REFERRAL REPORT

Report Date: April 21, 2020
Contact: Theresa O'Donnell
Contact No.: 604.673.8434
RTS No.: 13841
VanRIMS No.: 08-2000-20
Meeting Date: May 26, 2020

TO: Vancouver City Council
FROM: General Manager of Planning, Urban Design and Sustainability
SUBJECT: CD-1 Rezoning: 486 West 26th Avenue

Perspective: Cambie Street Facing South East

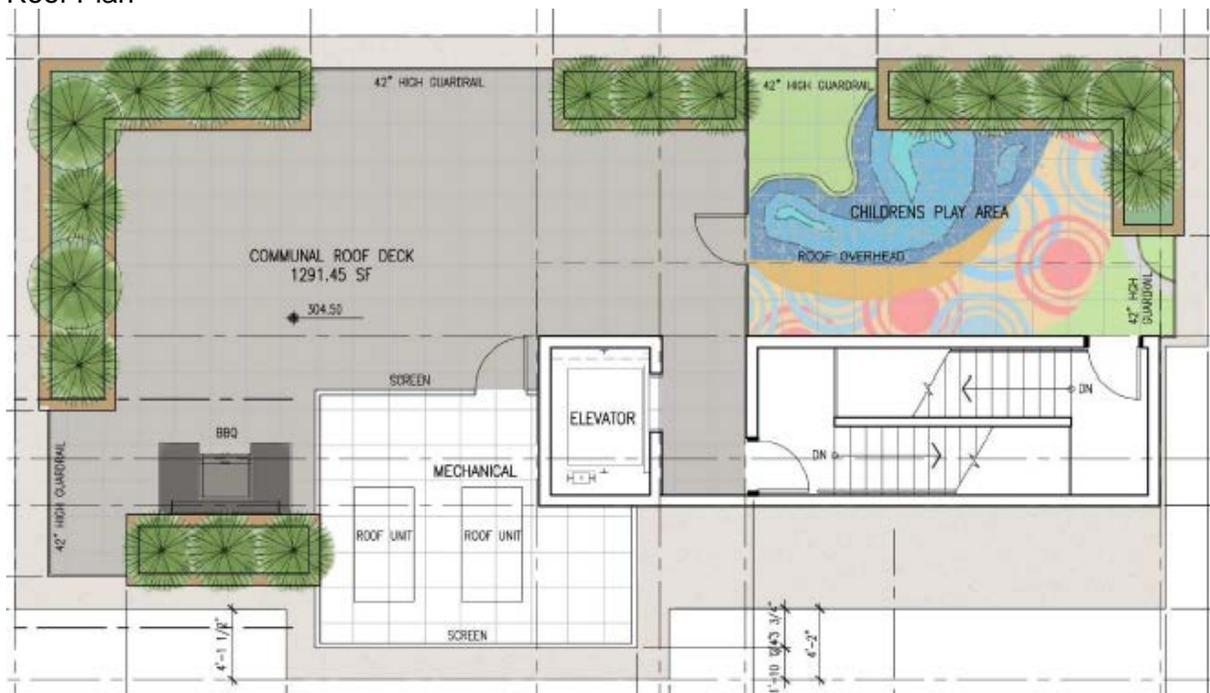
- (c) Enhance south elevation facing neighbouring courtyard.
- Note to Applicant: This can be achieved with colour, patterning, or robust planting given the southern orientation.

4. Minimize perceived height on all elevations.
- Note to Applicant: Setback rooftop planters a minimum of 0.6 m (2 ft.) from the face of exterior walls below.

5. Consideration to add robust green roofs at third and fifth storey in addition to proposed green roof on rooftop (See landscape condition 11).
- Note to Applicant: Green roofs provide a visual and social amenity, as well as contributing to the building's performance with regards to the City's sustainability objectives.
